Disability Standing Committee

STATE OF NEW MEXICO
GOVERNOR'S COMMISSION ON DISABILITY

ACCESSIBLE BARRIER REPORT
Americans with Disabilities Act
and
2021 IBC with ICC A117.1-2017

Thank you for the opportunity to be of service to you by performing an accessibility evaluation for the Employee spaces of the New Mexico Workforce Connection located at 501 Mountain Road Albuquerque, New Mexico. The facility was inspected on 10/23/2023.

SIGNAGE (NMBC 1110.1 and ICC A117.1 Section 502.7)

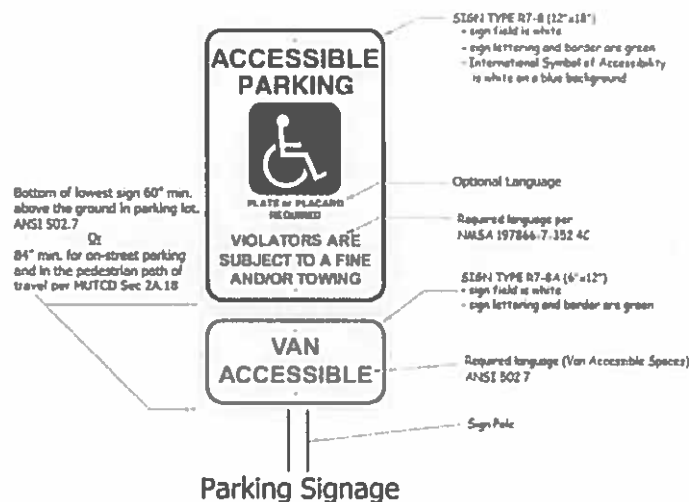
Two of the five identified accessible parking stalls currently located at 301 W. DeVargas do provide the proper code required signage, centered at the head of each parking space. The remaining three stalls should provide signage with the following items to ensure compliance.

- *GCD recommends signs to be white background with a green border and legend (MUTCD sign # R7-8 and R7-8A).*
- Sign must include the language “Violators are subject to a fine and/or towing” (66-7-352.4C NMSA 1978, Effective 7-01-2010). See sign sample below.
- In parking lots the bottom of the sign is required to be 60” minimum above the ground or parking surface. (ANSI 502.7).

Ramp exceeds 1:12 slope.

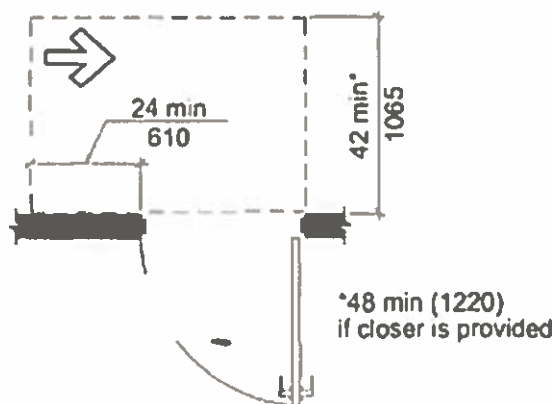
We observed several employee entrances. The first on the south end of the west side appears to be a break area and required steps down to the pavement without a ramp being present. I believe an 'exit' sign was in the interior space directing staff to a second entrance down a short corridor. At this second west side of the building exit there were steps as well as a ramp. This ramp is steeper than 1:12, and thus is not accessible.

This ramp occurs in the employe parking area and exceeds the maximum slope of 1:12. Signage in the employee break area adjacent through a short corridor with directional exit signage to this exit door, it serves as an accessible route exit and should be brought into ADA compliance. The gate at the top of the ramp with barbed wire topping may provide an alternative ramp area, which might be connected with the adjacent break room providing accessible exiting from both spaces as a possible solution.

Alcove entry into bathroom

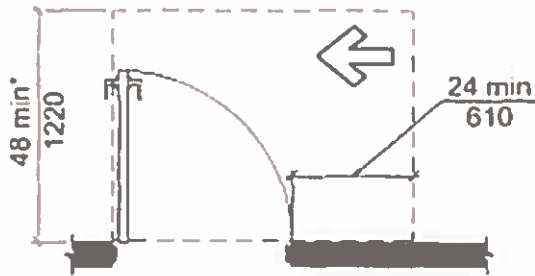
Note that the perpendicular measurement from the hinge side of the face of the door calls for a 42” minimum distance to the face of the wall, and a 48” minimum if the door is equipped with a closer, which this door is. The measurement from the center of the door to the wall is 49”.

Perpendicular to the hinge the clearance dimension is insufficient. However, if the door is equipped with a power assisted device as this one is, then the door approach requirements are acceptable. If the power assist is not operational, then the approach dimensions are noncompliant with the ADA Standards of 5 pounds of pressure to open the (interior) door. GCD recommends the bathroom doors be checked for power assisted operation daily, and if power assist is not operational, service should be attended to as soon as possible.
